**UNITED STATES
NUCLEAR REGULATORY COMMISSION**
WASHINGTON, D.C. 20555-0001

ZION NUCLEAR POWER STATION, UNIT 2

AMENDMENT TO FACILITY OPERATING LICENSE

Amendment No. 167
License No. DPR-48

Figure 3.1.3-1
Fuel Assembly Burnup Limits in Region 2

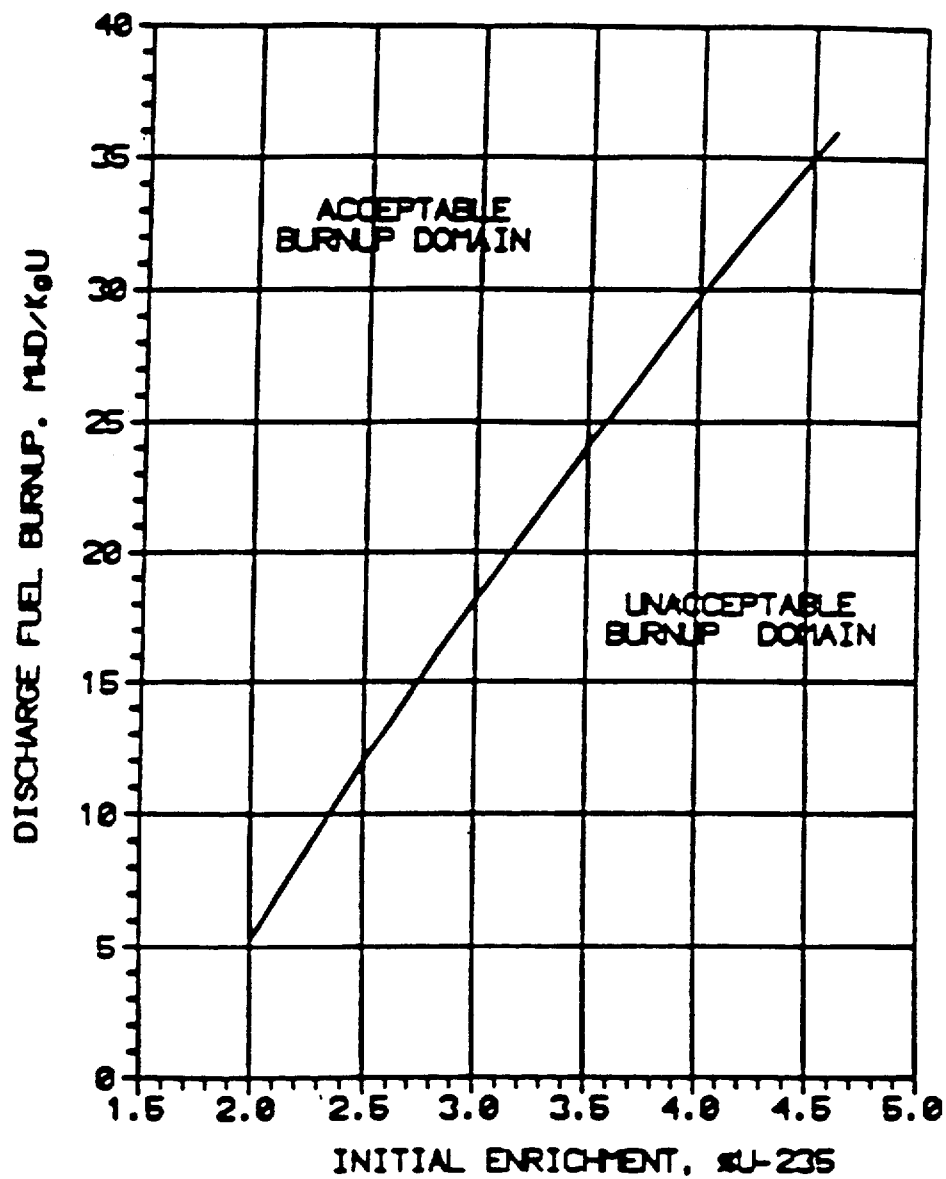
LCO 3.1.3 The combination of initial enrichment and discharge fuel burnup of each spent fuel assembly stored in Region 2 shall be within the Acceptable Burnup Domain of Figure 3.1.3-1.

- f. Irradiated fuel assemblies with a discharge burnup in the "acceptable burnup domain" of Figure 3.1.3-1 allowed unrestricted storage in either Region 1 or Region 2 of the spent fuel storage rack(s); and

- g. New or irradiated fuel assemblies with a discharge burnup in the "unacceptable burnup domain" of Figure 3.1.3-1 stored in Region 1 of the spent fuel storage racks.
